FIVE ESTUARIES OFFSHORE WIND FARM

10.20.1 TECHNICAL NOTE: METHODOLOGY FOR DETERMINING MDS (OFFSHORE) (CLEAN)

Application Reference:	EN010115
Application Document Number:	10.20.1
Revision:	B
Pursuant to:	Deadline 4
EcoDoc Number:	005395492-03
Date:	December 2024

Figure 1 Offshore cable crossings

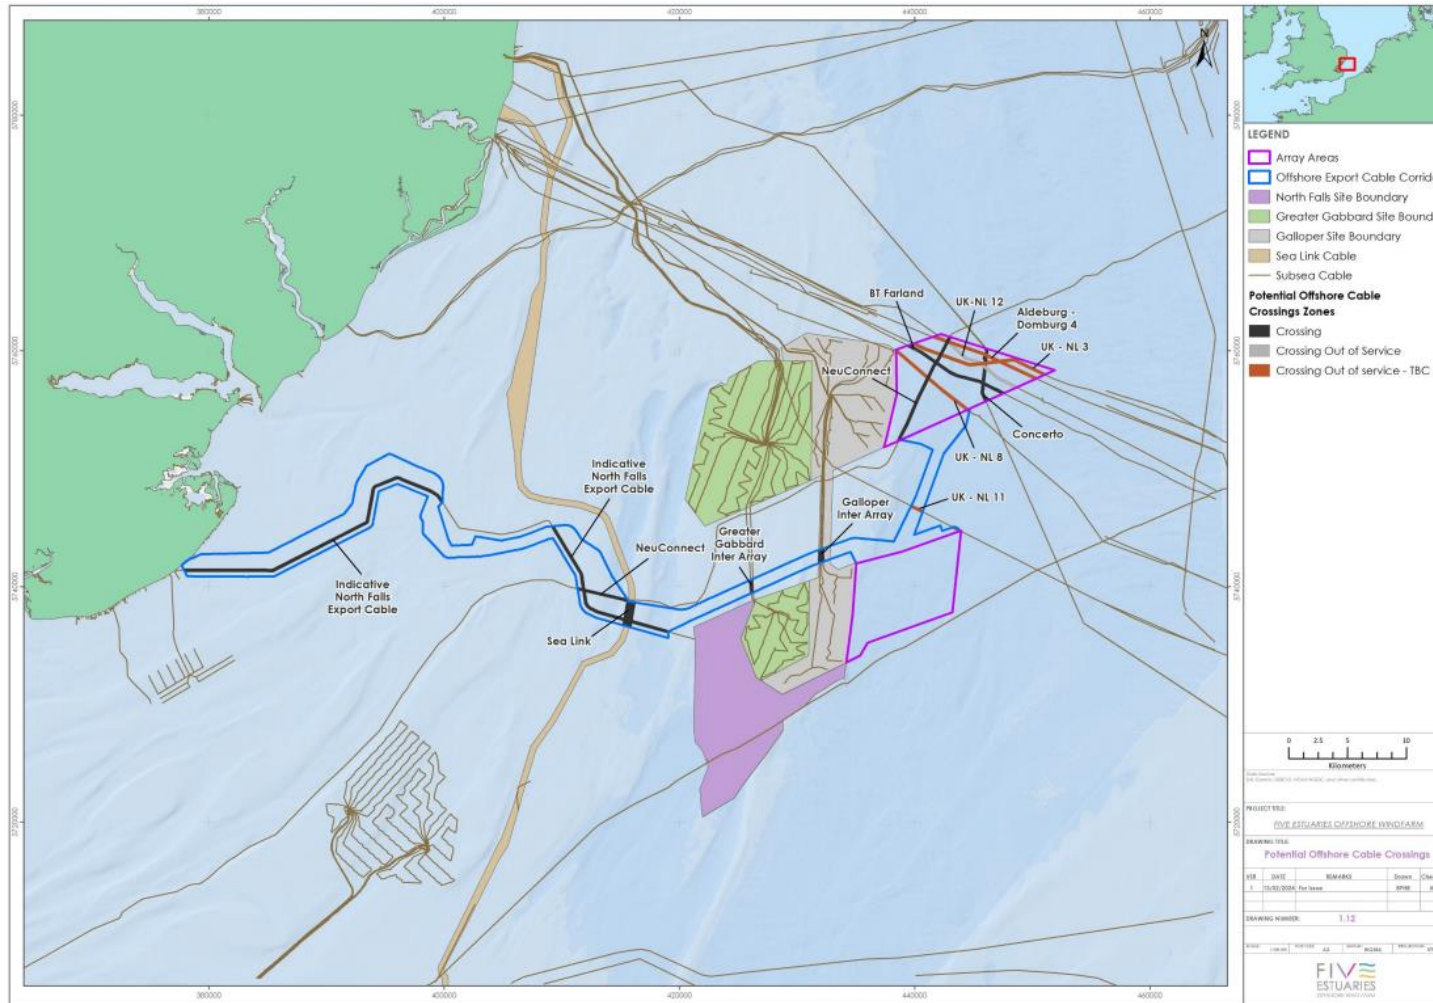
<p>b) Paragraph 2.1.3 restates that the maximum number of cable crossings has been set at 56. The Applicant must present a detailed explanation of how this parameter has been established, including any assumptions made.</p>	<p>Further details are provided in Section 2.1.</p>
<p>c) Paragraph 2.2.2 refers to the potential for a very small volume of sediment being trapped within rock voids and/or accumulating on the updrift side of berms of the cable protection, if required. The Applicant is requested to quantify the volume or provide an estimate of the maximum expected volume of such sediment.</p>	<p>An estimate of the volume of trapped sediment has been provided in Section 2.2. Context for this volume is provided in relation to the tip of the Margate and Long Sands (MLS SAC) sand bank which intersects the Export Cable Corridor (ECC). The relative volumes of potential trapped sediment and the tiny proportion of the nearby sandbank demonstrate that the potential effect of the project is not material.</p>

2.1.4 Figure 1 has been extracted from the Offshore Project Description [APP-069](#). It can be seen that there are a number of planned, active, inactive / out of service cables in the Export and Array area. This has been further summarized in Table 2.

- 2.1.5 The project has allowance for 56 cable crossings. At least 14 of these are anticipated to be for the export cables in the Export Cable Corridor (ECC). This leaves 42 for the array areas. It is not possible to identify the number of crossings in the array area until the final layout and array routing has occurred, and this will not be done until after DCO award. Similarly there are a number of OoS cables where though it is assumed the preference is to but remove these, however this is not confirmed yet. This is why the project cannot confirm the total number of crossings and instead has to make an allowance based on a range of possible scenarios.

Figure 5 Assumed external protection trapezium. Please note that bottom width is stated as 9.7m as it has been rounded to 1 decimal place

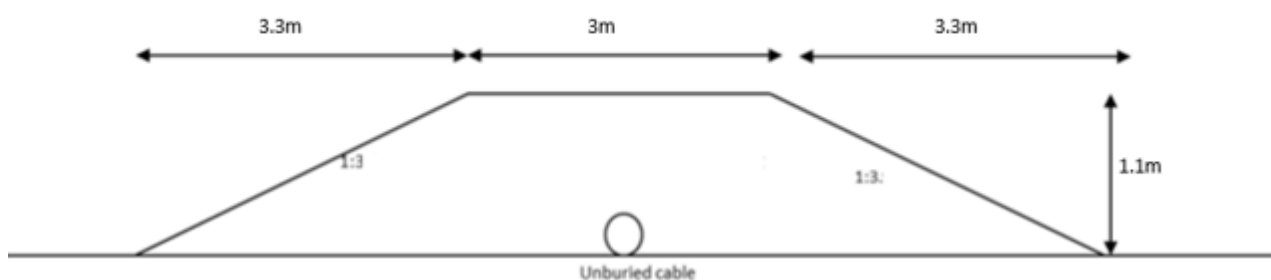
- 2.2.1 Within ExQ2 ME.2.05 the ExA has requested the Applicant to quantify the volume or provide an estimate of the maximum expected volume of the very small volume of sediment that may be trapped within rock voids and/or accumulated on the updrift side of berms of the cable protection (if required).
- 2.2.2 To provide both a calculation and context for the 'very small' volume of sediment the Applicant has referred to, the parameters from Table 1.24 in the Offshore Project Description [APP-070](#) are used.

2.2.3 To calculate the volume of cable protection, the cross sectional area based on the above parameters is calculated, using the equation for the area of a trapezium:

2.2.4 The area for the trapezium is therefore calculated as 7m² which can then be multiplied by the length of cable protection to provide the volume.

Figure 6 Location of transect from the export cable route to the M&LS northern edge

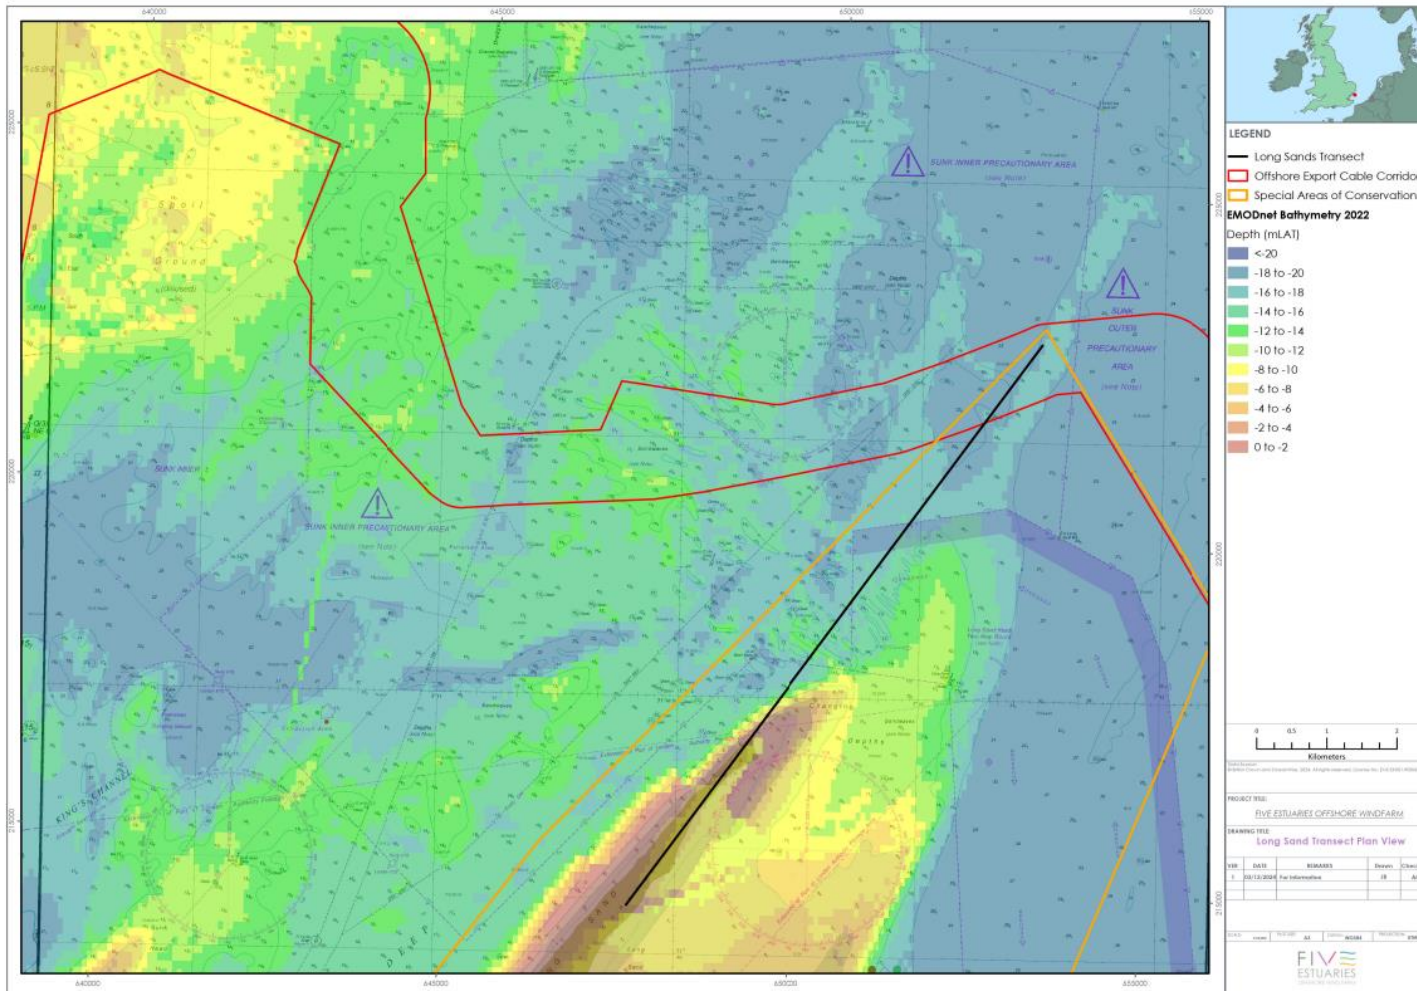
<p>d) Paragraph 2.2.4 states that monitoring and observation of operational offshore wind farms shows that large scale morphological features are not affected by the presence of assets (cable protection) and that scour</p>	<p>Covered in section 2.2.92.2.12.</p>

- 2.2.7 To put this in context of the size and proximity to the Margate and Long Sands sand bank a transect is shown below in Figure 6 and Figure 7. Transects at 1:20 and 1:50 scale are provided in Annex A: Transects at 1:20 and 1:50 V:H scale (printed at A3)

2.2.8 The Applicant cannot find a reported value for the volume of material in the Margate and Long Sands Sand bank, hence a conservative estimate is made below:

For the 4000m shown in the figure **which is circa 10% of the total length** from the northern tip to the southern this equates to 24 million m^3 of sand.

Figure 9 Sediment dispersal during jetting (IMCA Code of Practice for Offshore Cable Laying in the Renewable Energy Industry M264 Rev. 0.1 – November 2023)

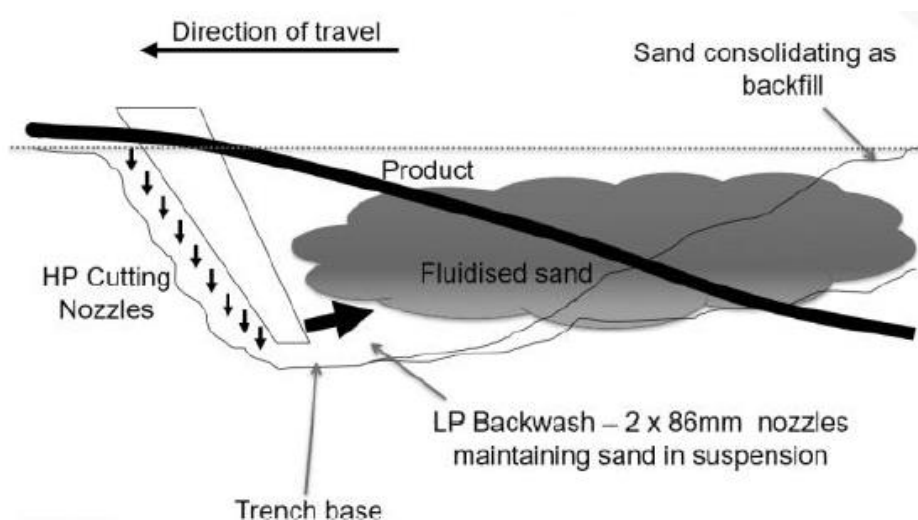
<p>impacts would be very small. The Applicant is requested to ExQ2 Responses by Deadline 4 (3 December 2024) Page 13 of 29 Question to: Question submit evidence in support of this</p>	
<p>e) Paragraph 2.4.2 states that a 50% assumption has been applied to sediment disturbed from fluidised material dispersed during cable trenching. This information seems to contradict the Applicant's response at Deadline 1 [REP1-051] that an assumption of 100% of material is fluidised and displaced. The Applicant is requested to clarify what has been considered in the assessment. The ExA notes that Table 2.8 in [APP-071] states that a sensitivity check on 100% of material ejected in local areas was undertaken. The Applicant is requested to confirm where this is presented in the Application documentation.</p>	<p>Further explanation is provided in Section 2.5.</p>
<p>f) A full response to the matters raised by Natural England in items B13 [PD2-004] and E6 and E7 in [PD2-006] should be provided in terms of how seabed disturbance from operational cable repairs and replacement has been calculated drawing on experience (including analysis from operational offshore wind farms) and ground type information.</p>	<p>The matters raised by Natural England (noting at E6 and E7 are in [PD2-007]) relate to the quantification of cable repairs and associated impacts. This is responded to in Section 4.</p>

2.6.2 The values in this table are estimated with a 50% assumption, regarding the amount of sediment disturbed. This value is used because during the trenching not 100% of the material is dispersed into the water column. An example of this for jetting is shown in the sketch in Figure . Some of the sand is fluidized into the water column and may disperse, however some backfills over the cable. The values in the table for the maximum volume are calculated from a typical average burial depth of 1.75 m, the maximum value of 3.5 m is a maximum indicative value. The actual burial depth will be below the average, hence this value has been used to assess the impact of sediment dispersal on sensitive receptors in the marine environment.

- 2.6.4 The initial calculations in the Environmental Assessment were more realistically based on the assumption of 50% ejected material as provided in the engineering estimate. The summary results (summarised in Paragraph 2.10.7 et seq. in [APP-071]) include any and all activities causing sediment disturbance, some of which are greater than the impact for trenching alone, i.e. cable installation (trenching) with the assumption of 50% ejected material was not the MDS for all potential causes of sediment dispersal and deposition. Following Section 42 consultation, additional internal sensitivity checks were undertaken to confirm that this still applied if an assumption of 100% ejection is also considered. Following this check, the Applicant was satisfied that even using the unrealistic assumption of 100% material ejected during trenching, cable installation would not result in greater sediment disturbance than the assessed MDS.

Figure 10 Maximum length of cable in SAC

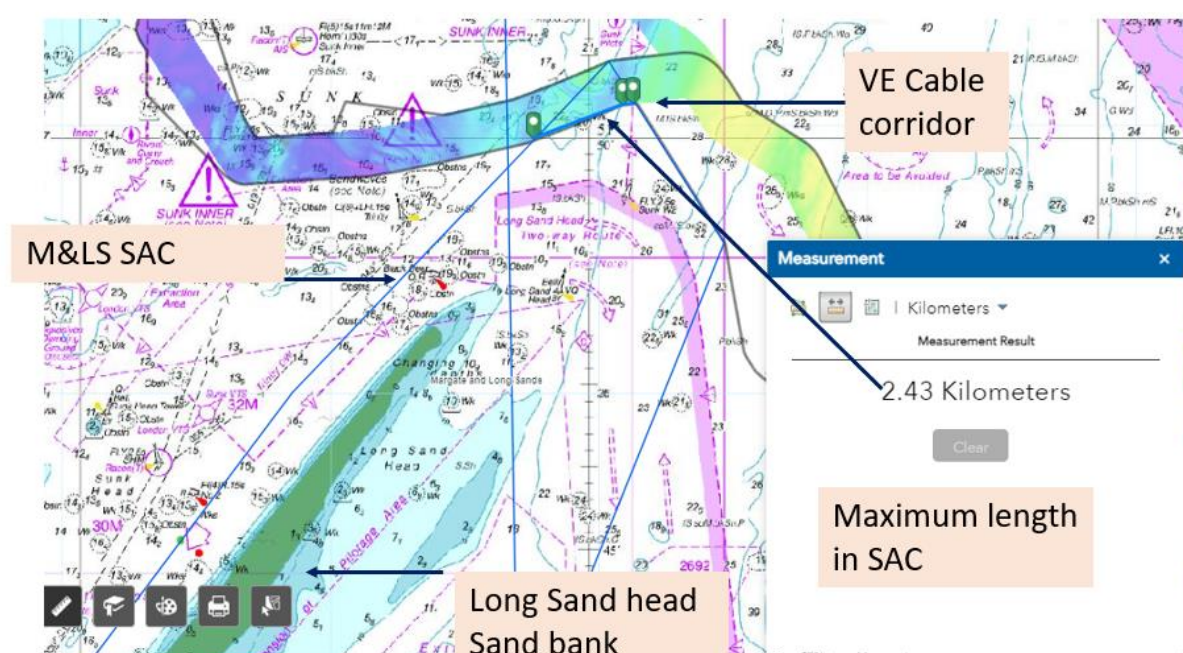
3.1 HOW HAS MAXIMUM LENGTH OF CABLE PROTECTION REQUIRED WITHIN MARGATE AND LONG SANDS (MLS) SPECIAL AREA OF CONSERVATION (SAC) BEEN DETERMINED?

3.1.1 Theoretical max single cable length is estimated at circa 2.5 km as shown in Figure below. It can also be seen that the Long Sand Head sand bank feature is 4-5km from the cable corridor and separated by the Long Sand Head two way route (Shipping Lane) used by vessels transiting to the ports.

- 3.1.2 This would be hugging the southern corridor edge. The project cannot conduct the final routing until post DCO, however the Applicant has committed to the following *“Final cable routing will seek to take the shortest route through the M&LS SAC where possible”* (9.13 Margate and Long Sands SAC Benthic Mitigation Plan [APP-243 Table 9.1]).

- 3.1.4 Based on the preliminary work conducted to date this is resulting in indicative routes with between 0.4-1.5km within the SAC.

3.1.5 A highly conservative assumption of 50% of the cable would require protection has then been applied to an assumed routing of 900 m per cable in the SAC. This has been combined with an assumed mattress width of 6m to result in the 5,400 m². This value is considered highly conservative by the Applicant and the most likely scenario is that no external cable protection will be used.
